**CITY OF EAST PALO ALTO, CALIFORNIA
DEPARTMENT OF PUBLIC WORKS – ENGINEERING DIVISION**

ADDENDUM 1

**BAY ROAD IMPROVEMENT PH. II AND III PROJECT –
CIP-ST-05A**

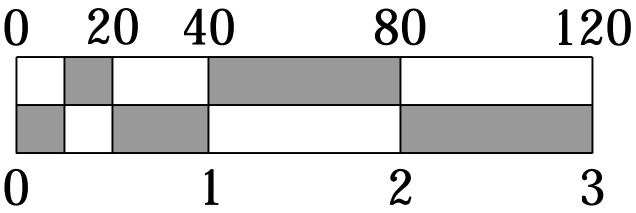
- Plan sheet 44 refers to cleaning the existing 72" pipe on Runnymede Street. I think we need a pay item and specification description of this work.

City Response: All the work associated with cleaning of the pipe on Runnymede Street is omitted. Sheet 44 is to be removed from the plan set. See Attachment 2.

Remove sheet

PREPARED FOR:		PLANTING PLAN BAY ROAD IMPROVEMENTS EAST PALO ALTO CALIFORNIA	
PREPARED BY:		SHEET 88 OF 93	
DATE:		10/08/18	
JOB #:		12064

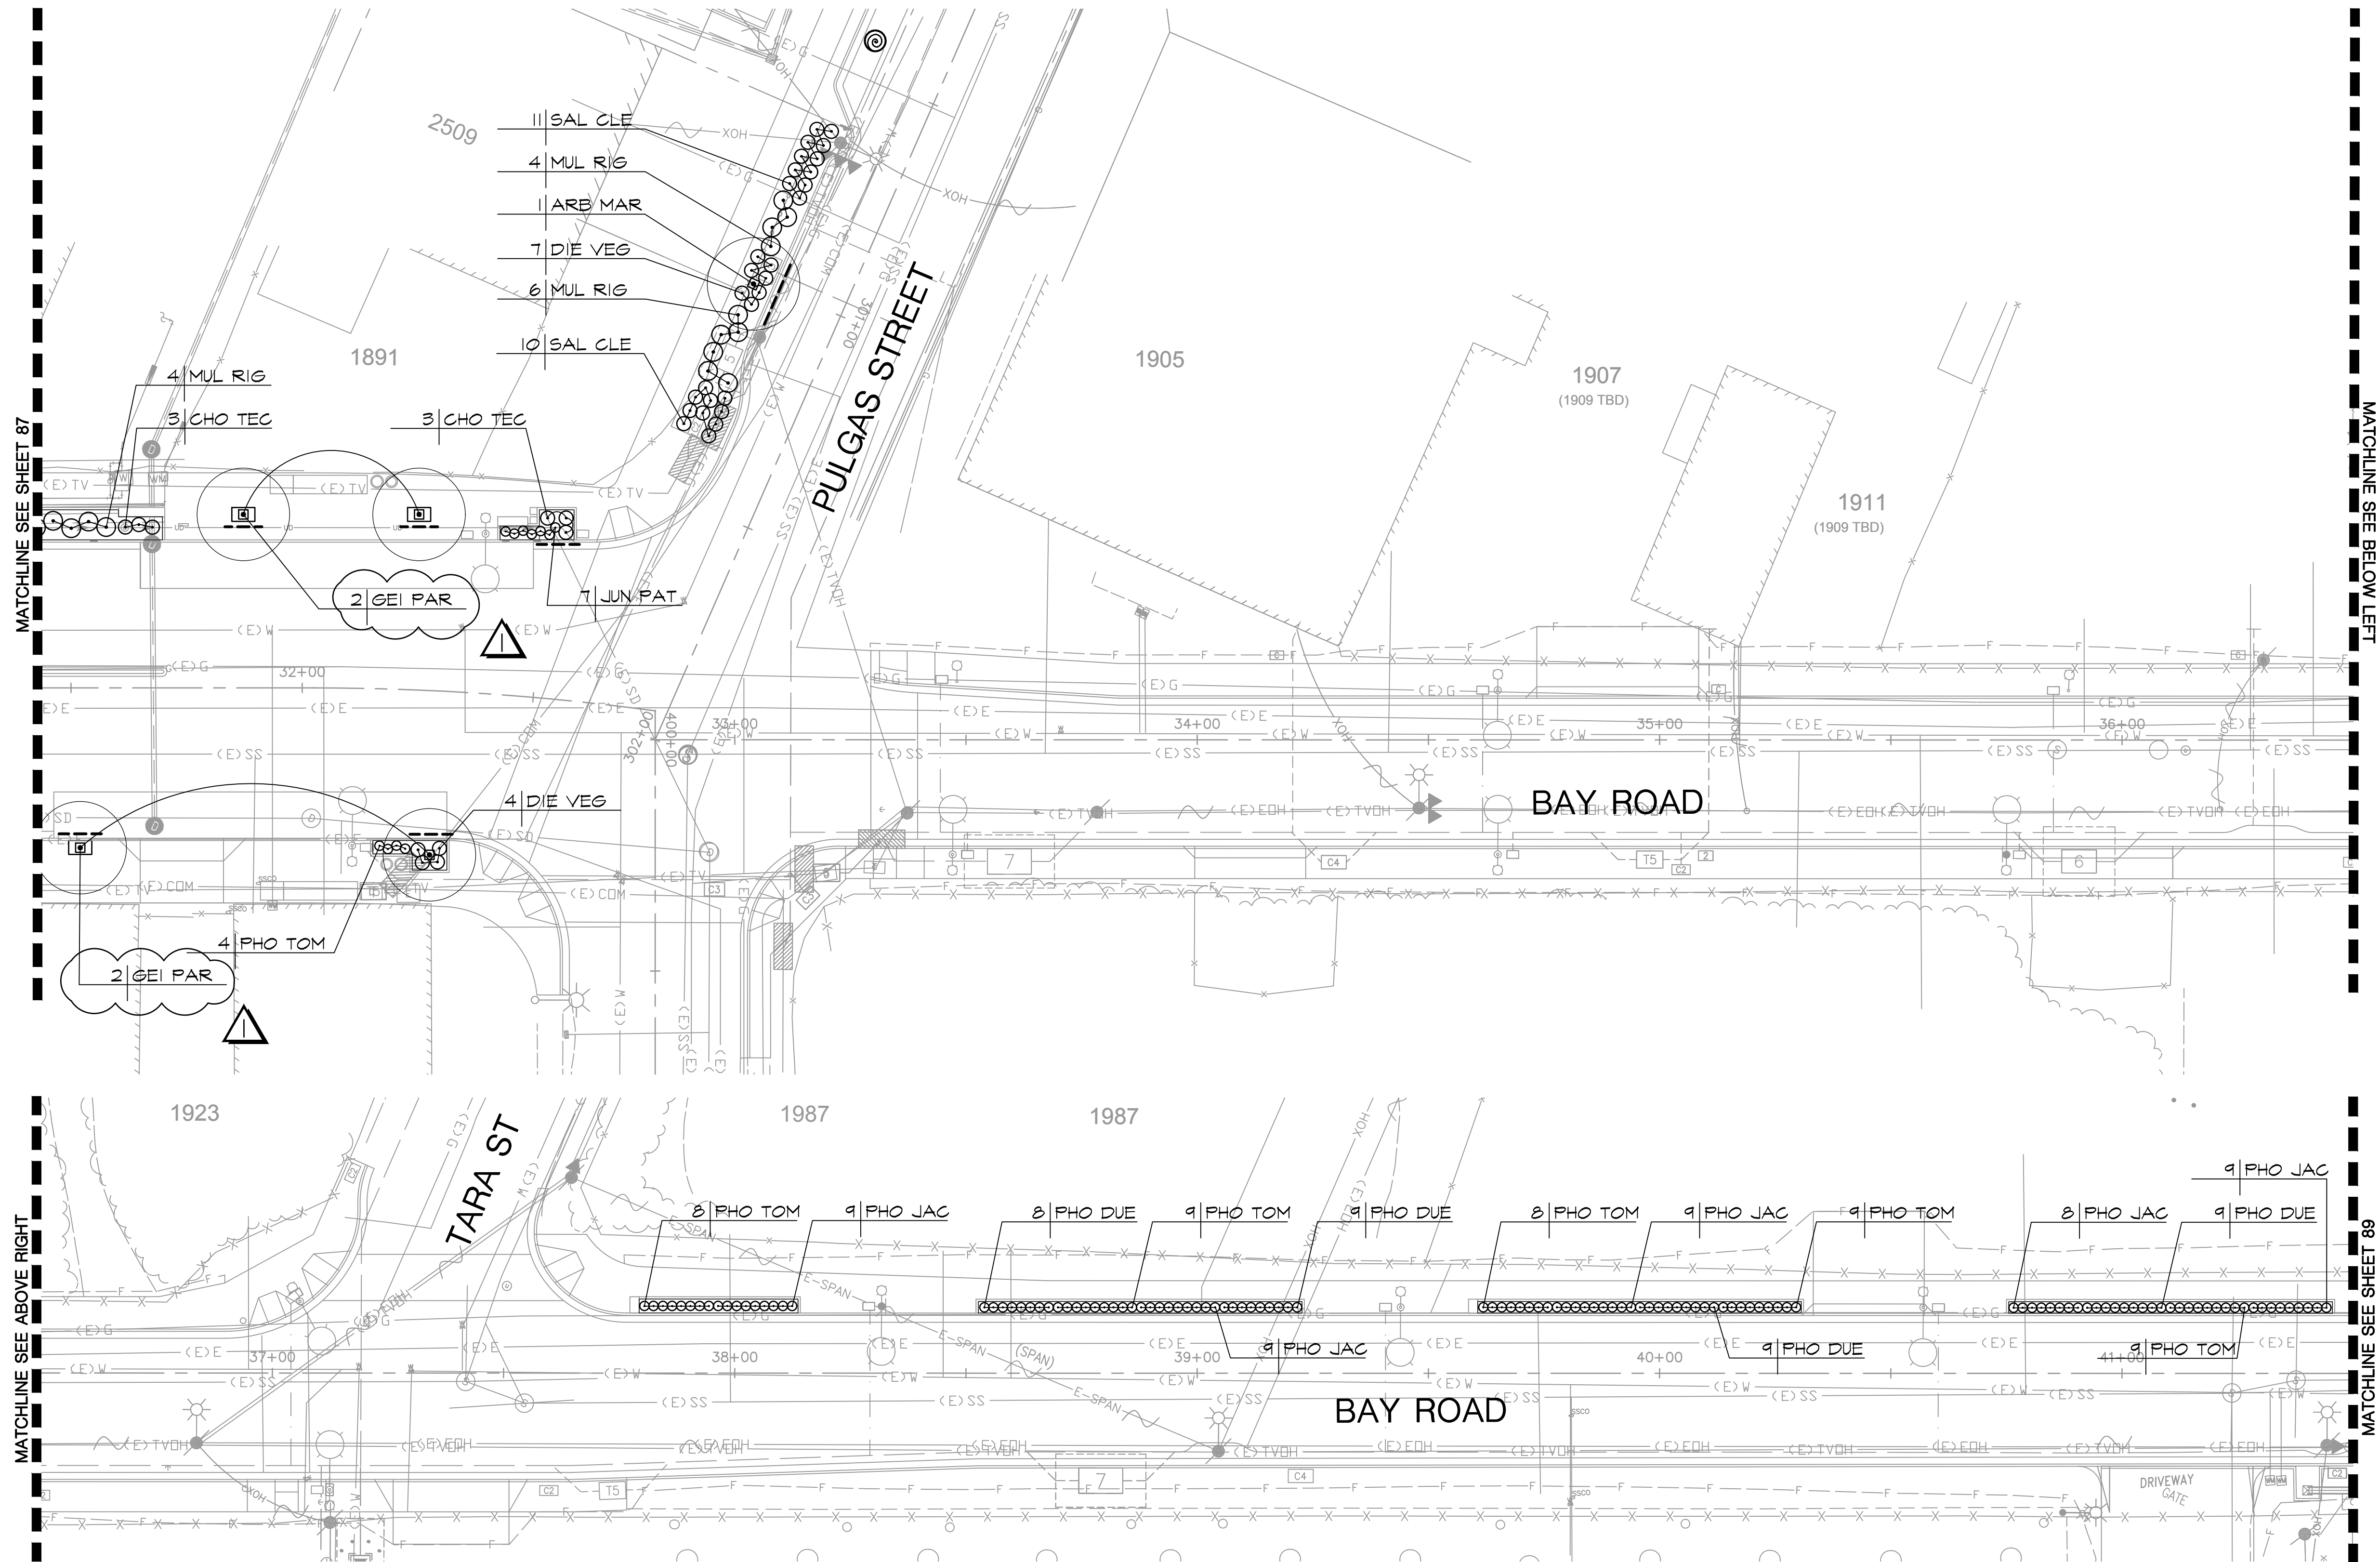
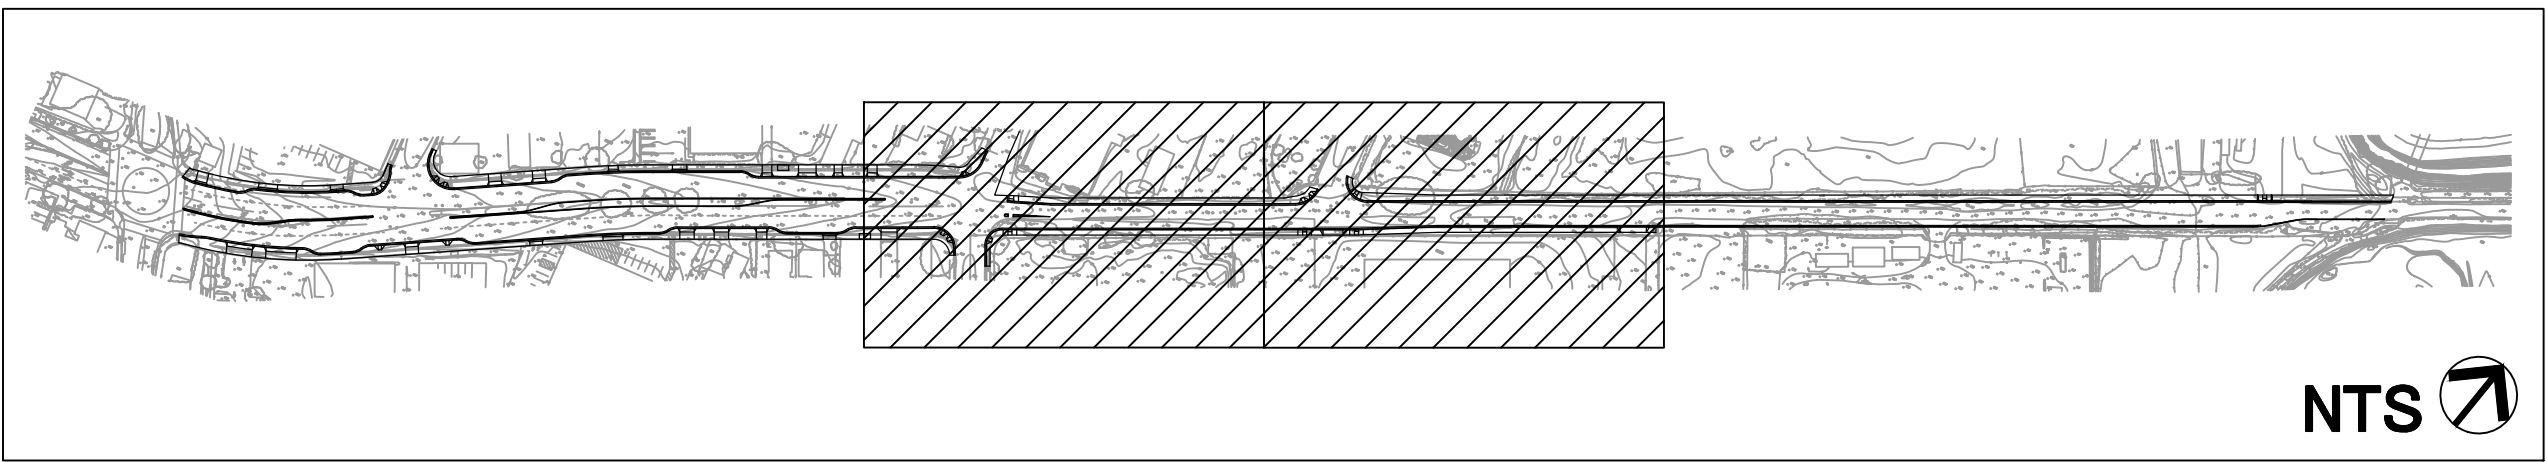
- On Sheet: 86, 87, Plant List: ALN RUB tree showed on Planting Plan (sheet 86) and not listed in Plant List.

City Response: Revised "ALN RUB" tree callouts on plan sheets 86-88 to "GEI PAR" to match Plant List. Also Added Arbutus 'Marina' to plant list on sheet 87 to correspond with "ARB MAR" tree callout on sheet 88. Revised plan sheets 86-88 have been included as Attachment 3 to this addendum.
